## PRODUCT CHANGE NOTIFICATION

#PCN-DC-GFJG-13

Business Unit	Product Line Code	Type of Change	Action	Date of issue
DC	ABN	Aesthetic	Notify Distributors and Field	10/7/2013

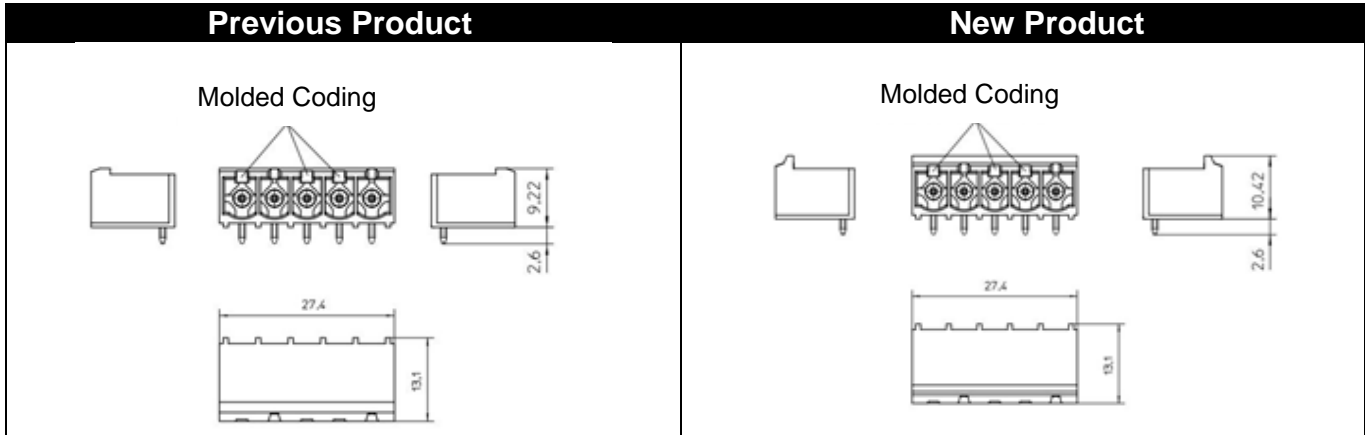
The aesthetic change has been made to allow the header to have a more secure fit in the panel mounting frame. The front edge has been increased from 9.22 mm to 10.42 mm.
